**Written submission from the
Kopit Lodge & Elsipogtog First
Nation**

**New Brunswick Power Corporation,
Point Lepreau Nuclear Generating Station**

Application for the renewal of NB Power's
licence for the Point Lepreau Nuclear
Generating Station

**Commission Public Hearing
Part 2**

Figure 3. Distribution of annual effective doses for workers at PLNGS from 2017-2020 (Source: CNSC, 2021)

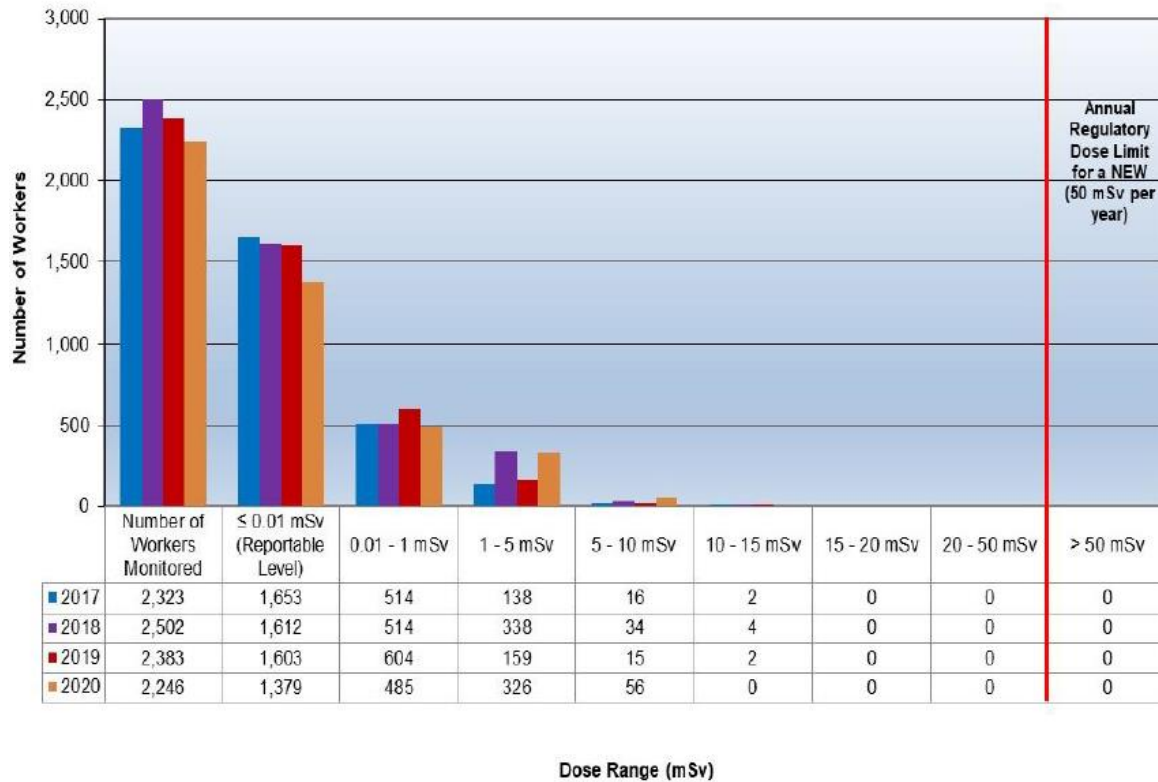
#	Comment	Request/Recommendation
29	The application outlines safe exposure doses for PLNGS employees and members of the public, but does not appropriately account for the heightened exposure Mi’kmaq people may experience as a result of harvesting, wild food consumption and being active on the land around the facility.	EFN and Kopit Lodge wish to be engaged in regulatory oversight and response regarding the potential radiation exposure for Mi’kmaq people who may work at or harvest around PLNGS and may therefore have heightened exposure.
